## Point-to-point actions in response to Anonymous Referee #1

Manuscript #: essd-2025-671

## **Response to the Reviewer 1:**

Figure 3

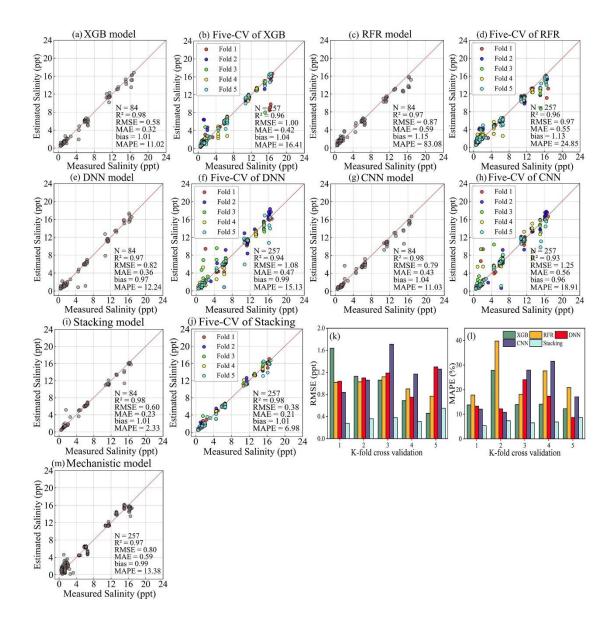
3) Figs. 3 and 13. Change "Measure Salinity (ppt)" to "Measured Salinity (ppt)" in all

x-axis labels.

**Reply:** Thank you for your professional suggestions. We have revised it.

(Page 14, lines 298-301; Page 27, lines 498-499)

Salinity maps derived from different models

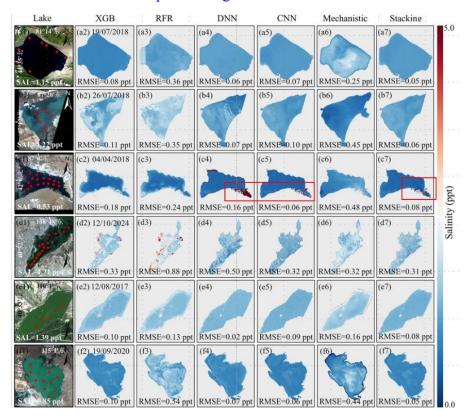
4) Fig. 6. I like this figure as it makes visual inspection straightforward. The lower salinity around the land-lake boundaries may be due to runoff, but what caused the high salinity points (reddish colors) in c7?

**Reply:** We greatly appreciate your recognition, and thank you for your thoughtful comments. Through observation and analysis of MSI natural color composite images and salinity maps derived from various models, we found that the high salinity in the land-lake boundaries of Lake Bosten was caused by DNN and CNN overestimates of salinity influenced by mixed pixels. This high value was not fully corrected by the integrated model. Additionally, we supplemented the explanation for the high salinity pixels appearing in Figure 6(c7) in Section 3.2.

(Page 16, lines 314-316) "However, salinity values in Lake Bosten's nearshore pixels were not fully corrected because the DNN and CNN models overestimate salinity influenced by mixed pixels (Figure 6(c4,c5,c7))."

Figure 11

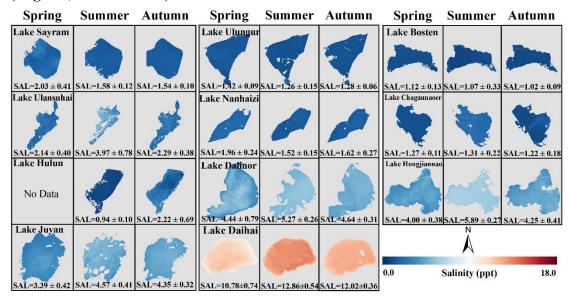
5) Fig. 11. Put some space between column 3 and column 4, and between column 6 and column 7.

**Reply:** Thank you for your pointing this out. We have revised it.

(Page 25, lines 404-406)
